CITY OF ST. PETERSBURG, FLORIDA
PLANNING AND DEVELOPMENT SERVICES DEPARTMENT
URBAN PLANNING AND HISTORIC PRESERVATION DIVISION

STAFF REPORT

Community Planning and Preservation Commission Certificate of Appropriateness Request

Case No.:	21-90200091
Address:	3218 8 th Ave. N.
Legal Description:	KENWOOD SUB ADD BLK 17, LOT 3
Parcel ID No.:	14-31-16-46350-017-0030
Date of Construction:	1927
Local Landmark:	Kenwood Section – Northwest Kenwood Local Historic District (18-90300008)
Owners:	Cori Smith Haynes
Request:	Review of a Certificate of Appropriateness for addition and alteration to 3218 8 th Ave. N., a contributing property to a local historic district.

Figure 3: Image from application showing proposed location of addition in pink

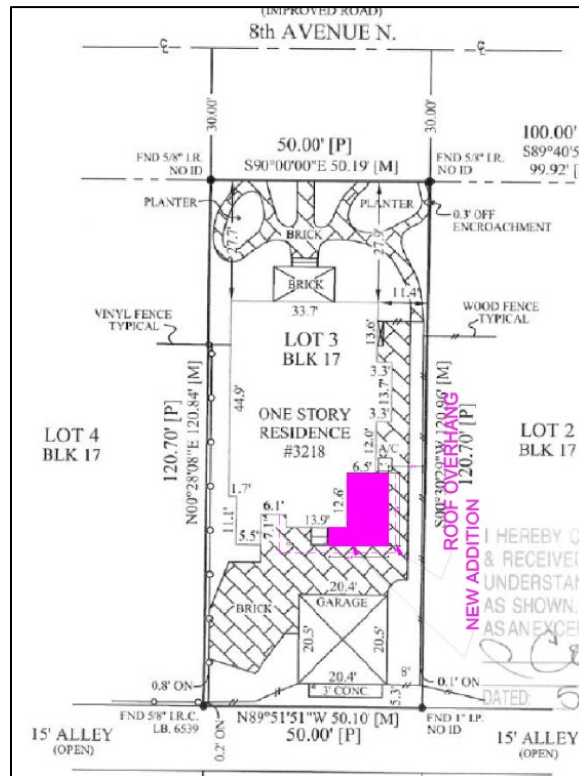
The owner proposes interior improvements (which are outside of the scope of this COA review) that will rearrange existing spaces in the residence that have been altered over time, including the kitchen and a sunroom. The addition of approximately 145 square feet of interior space will accommodate an added bedroom.

Property records indicate that the house has been expanded through a rear porch addition (now enclosed as a sunroom) in 1951 and the construction of a rear bathroom addition in 1957. Both additions are largely

obscured from the subject district by the building's primary side-gabled massing that faces the street. The proposed addition will be appended to the rear gable of the 1951 sunroom wing and remain behind the bulk of the primary residence.

Figure 5: Proposed floor plan, from application

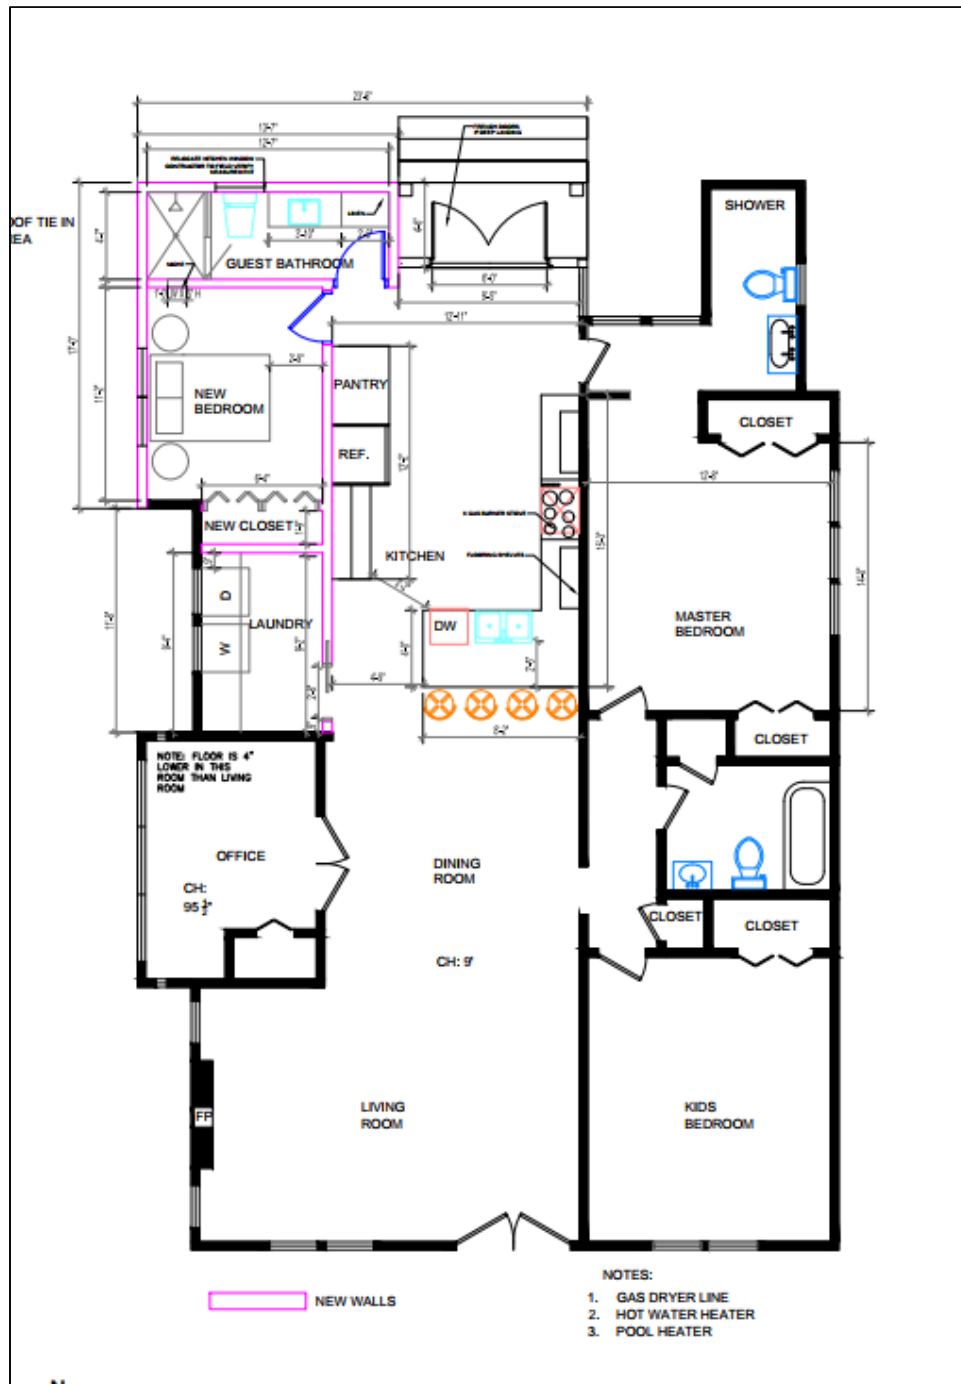
Consistent The proposed addition will be placed behind the existing residence and with a lower gable peak than that of the existing roof form.

Consistent The new windows will match the existing windows in configuration and size.

Consistent The proposed roof will add to the rear-facing gable of the now-enclosed 1951 porch addition.

1. Windows at addition will be installed to be setback within the wall plane and feature a reveal of at approximately two to three inches to provide consistency with the historic windows at subject property.
2. Proposed windows will replicate traditional design and configuration.
3. Vinyl fence will feature a matte finish.
4. All other necessary permits shall be obtained. Any additional work shall be presented to staff for determination of the necessity of additional COA approval.
5. This approval will be valid for 24 months following Commission approval, for an expiration date of September 14, 2023.
